RESOLUTION HOLDING HEARING ON REQUEST FROM HUBBELL REALTY COMPANY FOR THE 10TH AMENDMENT TO THE RIVERWOODS LEGACY PUD CONCEPTUAL PLAN FOR PROPERTY LOCATED IN THE VICINITY OF RIVERWOODS ROAD AND RIVER RIDGE AVENUE

Communication from the City Plan and Zoning Commission advising that at their May 6, 2021 meeting, the following action was taken regarding a request from Hubbell Realty Company (owner) represented by Steve Mosely (officer) for review and approval of a 10th Amendment to the Riverwoods Legacy PUD Conceptual Plan, for property in the vicinity of Riverwoods Road and River Ridge Avenue, to revise areas F, G, and H by eliminating the extension of River Ridge Road and reducing the length of the Grand River Drive cul-de-sac and increasing the open space/conservation area, as well as to add additional house typical designs.

PRELIMINARY CONCEPTUAL PLAN FOR RIVERWOODS AMENDMENT # 10

RIVERWOODS MASTER PLAN

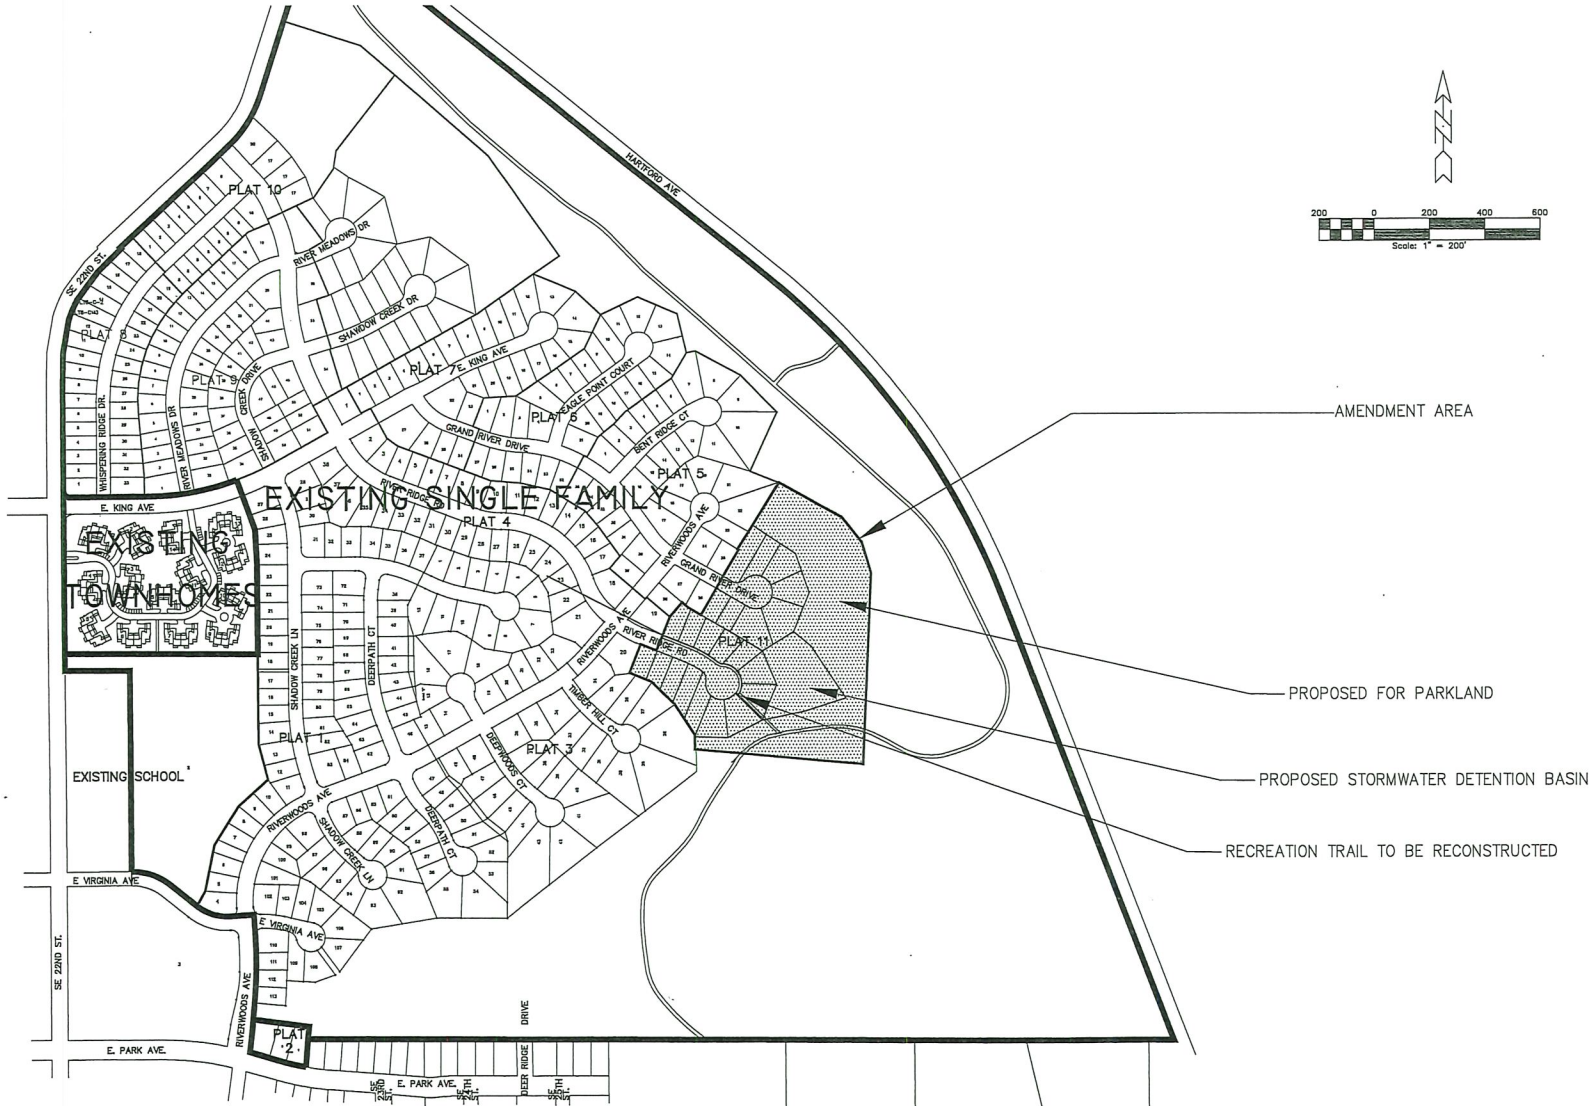
- 3. Traffic/Street System:** The proposed amendment to the “PUD” Conceptual Plan would revise the configuration of the one-household residential lots in “Area F” and would replace “Area G” and “Area H” with an open space/conservation area. The areas identified as “Area G” and “Area H” are within a parcel that is currently owned by the City of Des Moines. The proposed amendment would also eliminate the extension of River Ridge Road to East Park Avenue and reduce the length of the Grand River Drive cul-de-sac. Staff believes that these revisions are appropriate and would preserve a significant area of existing mature tree canopy. Planning staff also believes that the existing Riverwoods Avenue can accommodate the north/south traffic through the existing “Riverwoods” development to East Park Avenue.

- 4. Recreational Trail:** There is a 10-foot wide recreational trail (known as the Carl Voss Trail) that passes through the eastern portion of the “PUD” District, as well as a trail spur that provides access to the trail from River Ridge Road. Portions of this existing trail are within temporary easements that are conditional upon permanent easements being provided at the time the area develops. Therefore, staff recommends provision of a note stating that permanent trail easements shall be provided for the Carl Voss Trail and for the trail spur providing access to the trail from River Ridge Road, where these easements ensure that the trail shall not be moved or impacted by the developer.

Since the proposed River Ridge Road cul-de-sac would impact the trail spur that provides access to the Carl Voss Trail from River Ridge Road, staff recommends provision of a note stating that the reconfigured trail spur providing access to the Carl Voss Trail from the bulb of the River Ridge Road cul-de-sac shall be designed and constructed to the City’s standards as reviewed and approved by the City’s Park & Recreation Department Director.

Finally, staff recommends provision of an 8-foot wide sidewalk along one side of the River Ridge Road cul-de-sac to connect Riverwoods Avenue to the trail spur.

PRELIMINARY CONCEPTUAL PLAN FOR RIVERWOODS
AMENDMENT # 10

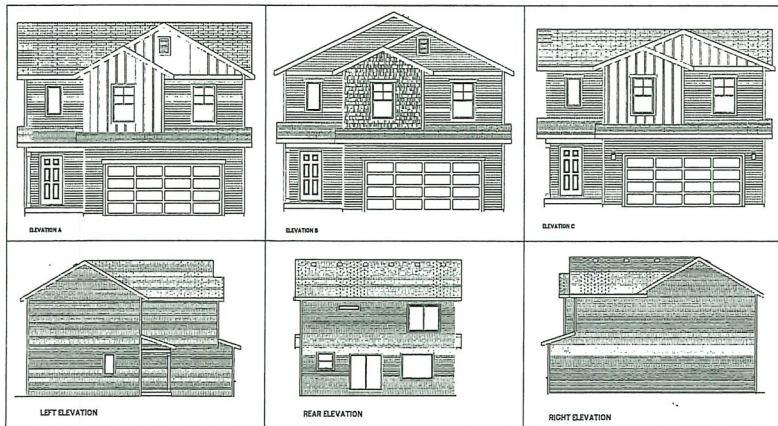
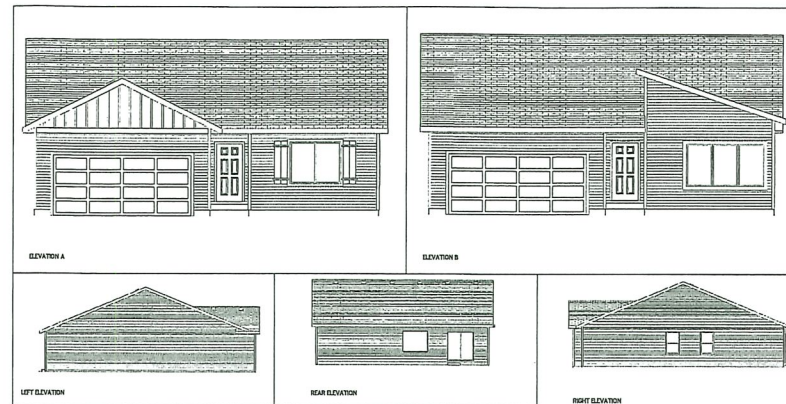
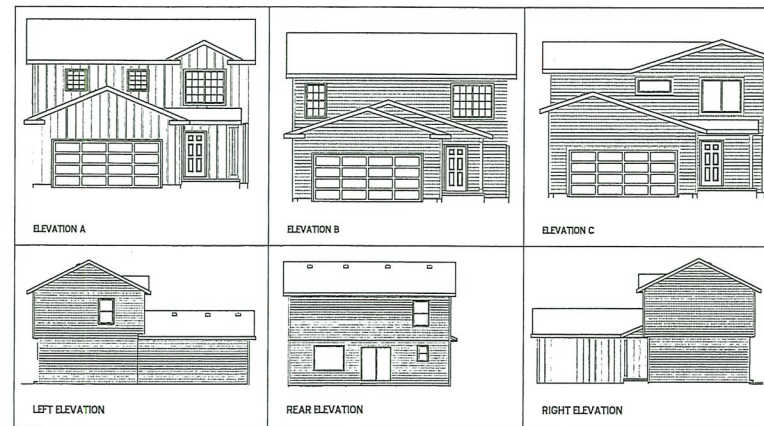
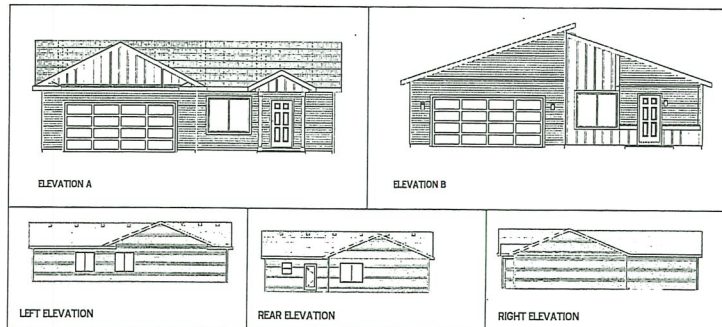
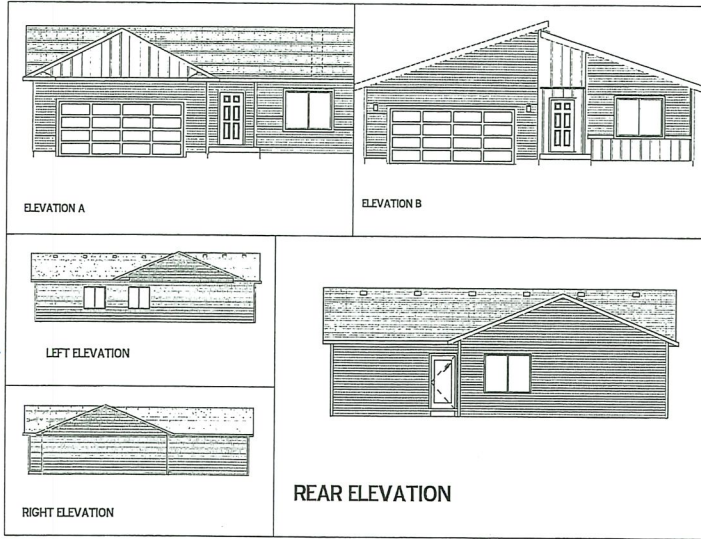
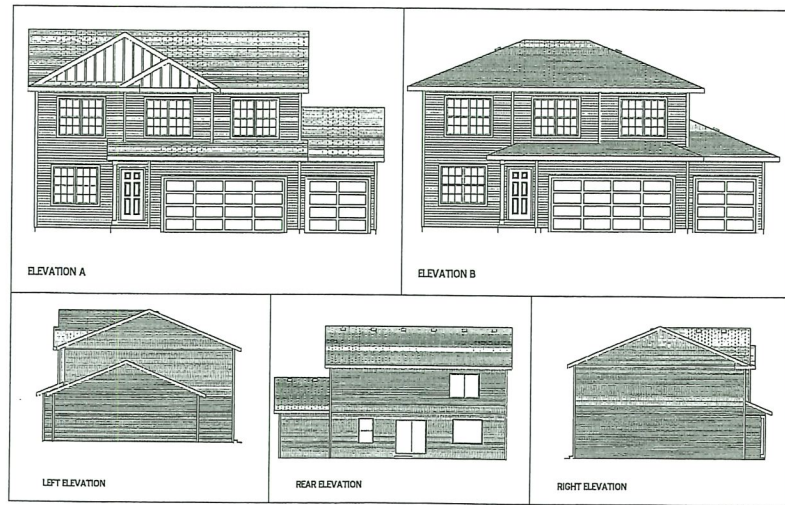
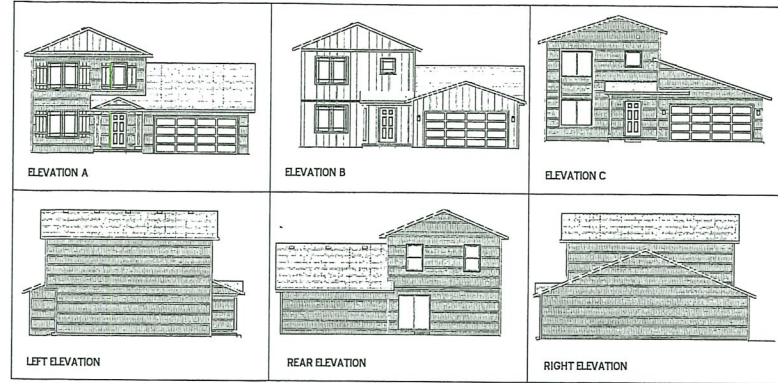
- 5. Urban Design:** The proposed "PUD" Conceptual Plan would essentially allow for a total of 22 lots, each at least 60 feet wide, for one-household development. The Conceptual Plan provides eight (8) character examples of front facades of homes that would be constructed. Staff has recommended the notes listed as "Condition 12" below, to ensure appropriate development.

Any house constructed shall match one of the PUD House Character Elevations, including illustrative trim and siding mixes. Material upgrades and alternative house design may be approved by the Planning and Urban Design Administrator.
- d) ~~All windows and doors on the front façade of any house shall have trim that is no less than 4 nominal inches in width.~~
- e) The roof on any house constructed shall be of asphalt type shingles or cedar shakes. Standard 3-tab shingles are prohibited.
- f) Any house shall be constructed with a minimum of 1,200 square feet of area.
- g) Exterior material for any house constructed shall be masonry (brick or stone), vinyl of no less than 0.042 thickness, cedar, masonite, LP Smart Siding, or fiber cement board.
